USED FOR LOCO WAG-9, WAP-7 & WAP-5 (3)

चित्तरंजन रेलइंजन कारखाना
CHITTARANJAN LOCOMOTIVE WORKS, INDIA

पदार्थ MATL	प्रति भार कि. ग्रा. WT. EACH IN KG
विशिष्टि SPECN	ASTM A108
वर्णन DESCRIPTION	UNION TEE SPECIAL
आरेखण संख्या DRAWING NO.	1209-18.306-031
परिवर्तन संख्या ALTERATION NO.	~~5~~ 6
पूर्ण SHEET	1 OF 1
	A3

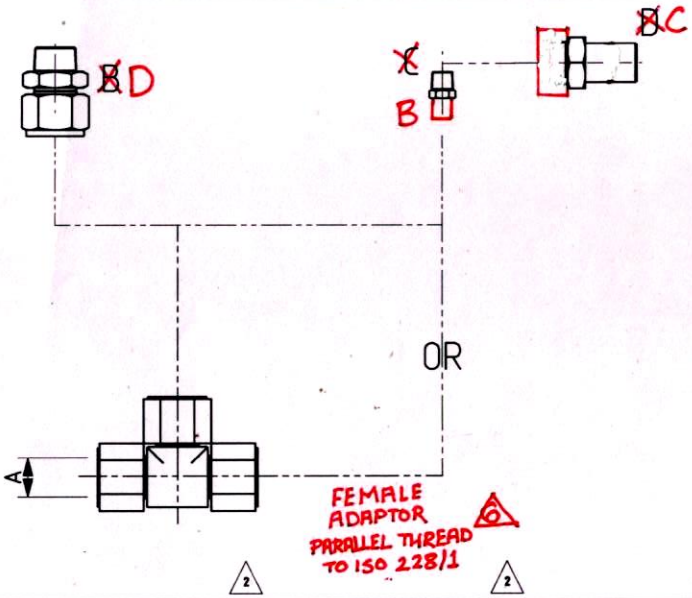
ALT. NO.	AUTHY	DESCRIPTION	DATED INITIAL
6	DY.CEE/ D-III	DESCRIPTION OF COLUMN 'C' CHANGED FROM 'PLUG' TO 'FEMALE ADAPTOR'. FOR SL. NO. 1, 3,5 PROPER SIZE OF 'FEMALE ADAPTOR' ADDED. FOR SL. NO. 3, MALE CONNECTOR TAPER THREAD SIZE CHANGED FROM 3/8" TO 1/2". NOTE 4 DELETED.
